Urgent Field Safety Notice **Moviplan 800**

Urgent Field Safety Notice (FSN)
Moviplan 800
Risk addressed by FSN

N. NIM003-2021
Date: *November 3, 2021*
Subject: *Pin soldering verification*
To: *Villa dealers*
Equipment: Moviplan 800

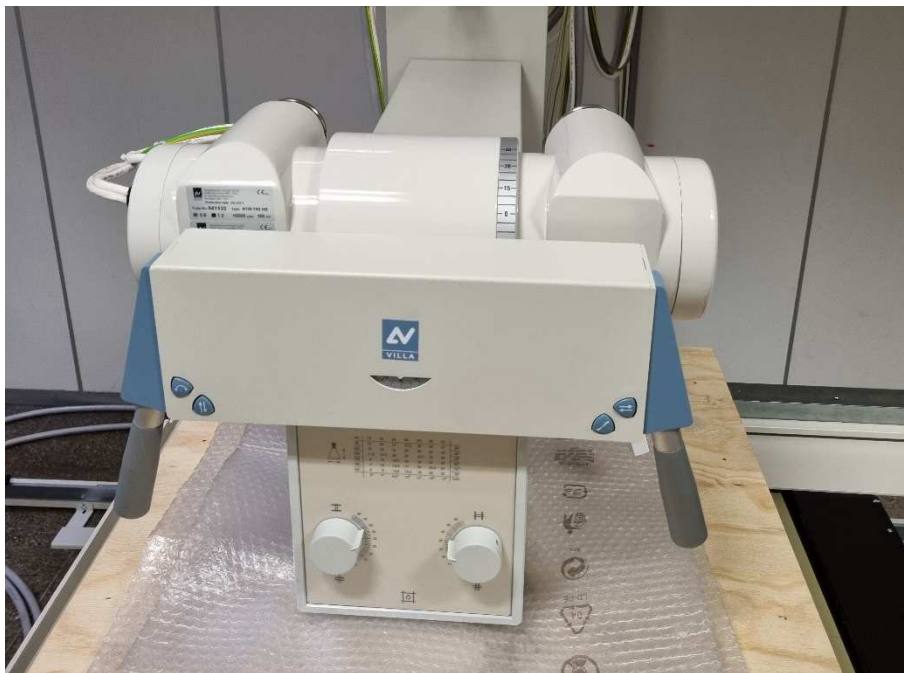
With this Note, we inform you that the some tube support shaft mounted on Moviplan 800 columns manufactured between April 2020 and March 2021 could have a non compliant welding due to the dimension of the welding throat.
In case you find this type of welding, it is required the tube support replacement.

Just for reference, here following the type of verification to be done in field on installed units, where it is visible, without dismounting x-ray tube, the difference between correct welding, that should have the weld throat size of about 4mm, and non compliant welding

In green you can see the correct weld throat size

For better understanding, here following the differences between a correct welding (green arrow) and a non compliant welding (red arrow).

In case it is necessary the replacement, the spare part code is:

6174791100 Tube support for Moviplan 800 column

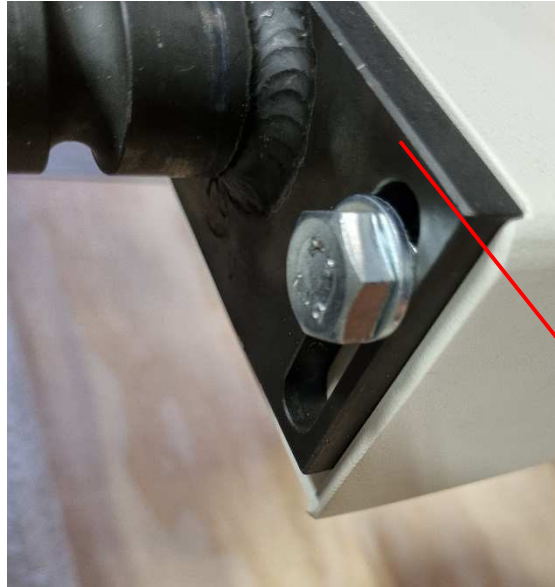
Position the column close to the table top centre in order to put on the tube group.
Protect table top surface in order to avoid scratches

Move bumpers in both sides against the column frame to avoid longitudinal movement of the column during replacement

Position the collimator in touch with table top and fix cursor using a locker plier and moving end run bumpers against cursor

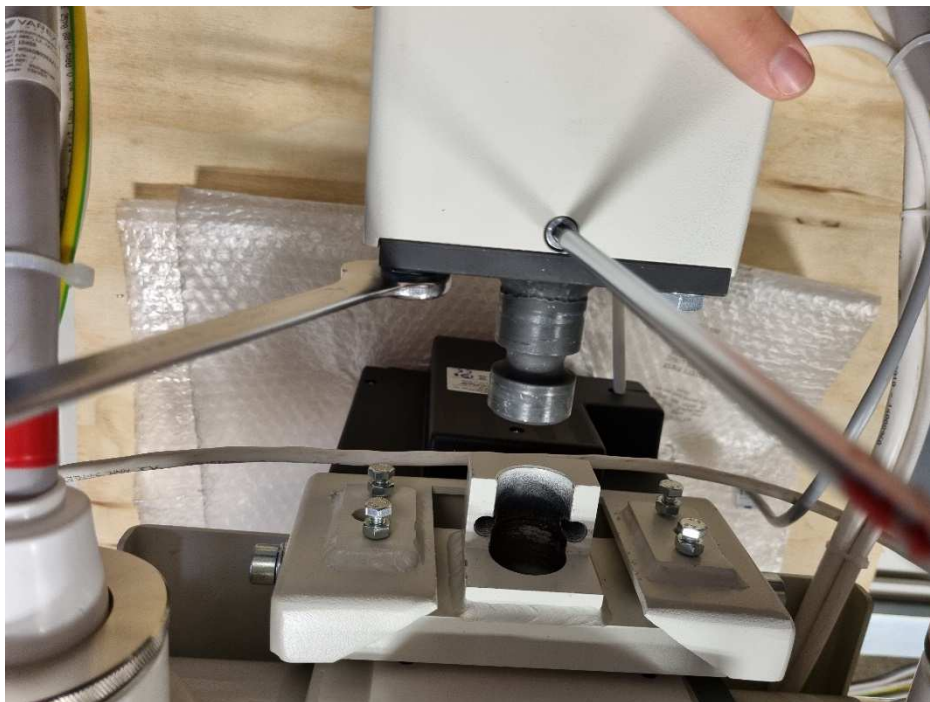
Remove the upper block screws

Pull out the tube group and leave it on the table top

Take a reference of the actual pin position

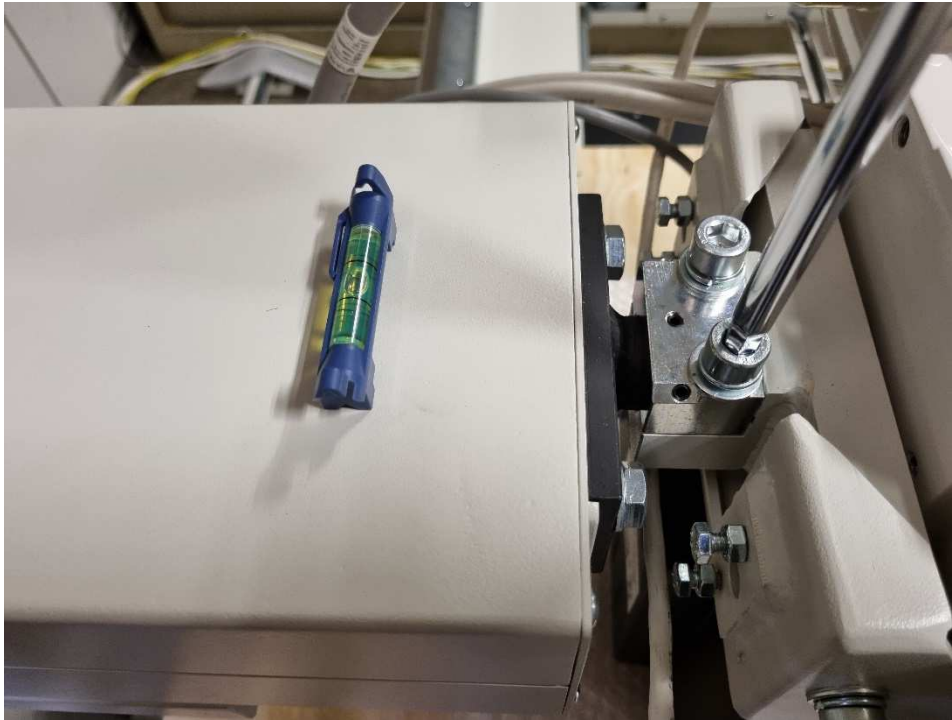
Remove the three fixing screws before the lateral ones, then the middle one

After pin replacement, mount the tube group, and verify if tube and column are at the same level using an air bubble. Fix the screws. Before fixing the grub screws, verify x-ray beam alignment
